Technical Bulletin 230

04.2023

Item: 230.4
Description: Encapsulated Fixings
Model Affected: All Models

Identification

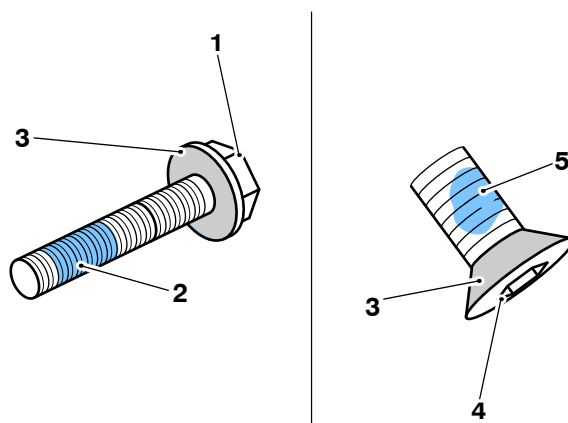
When carrying out any maintenance or repairs, unless a specified repair procedure states otherwise, encapsulated or patch locked fixings if disturbed or removed must be discarded and replaced with new. Encapsulated fixings can be identified on the Electronic Parts Catalogue (EPC) by the text 'Enc' in the part description.

Patch locked fixings can be identified on the Electronic Parts Catalogue (EPC) by the text 'Pat' in the part description.

- The motorcycles Service Manual will indicate where encapsulated fixings are used and the recommended torque tightening procedure.
- Thread locking compound must not be used except where stated in the appropriate service instructions.
- An encapsulated fixing can be identified when the diameter of threads is encompassed by the locking agent.
- A patch locked fixing can be identified by a section of thread which is treated with a coloured locking agent.

New Fixing Installation Procedure

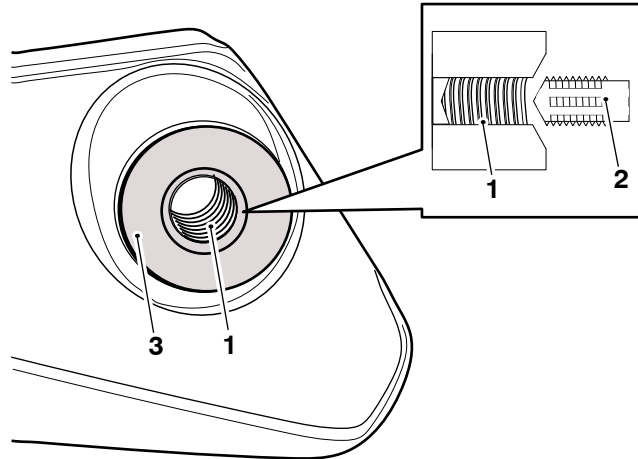
1. Inspect and if necessary, clean off any old locking agent and remove any burrs or sharp edges.
2. Using a proprietary cleaning agent, clean and dry the thread and its mating faces.

- When fitting new encapsulated or patch locked fixings make sure the threaded holes are cleaned, dried and free from old locking agent, grease and/or fluids.
3. Fit the new fixing and tighten to the required torque.
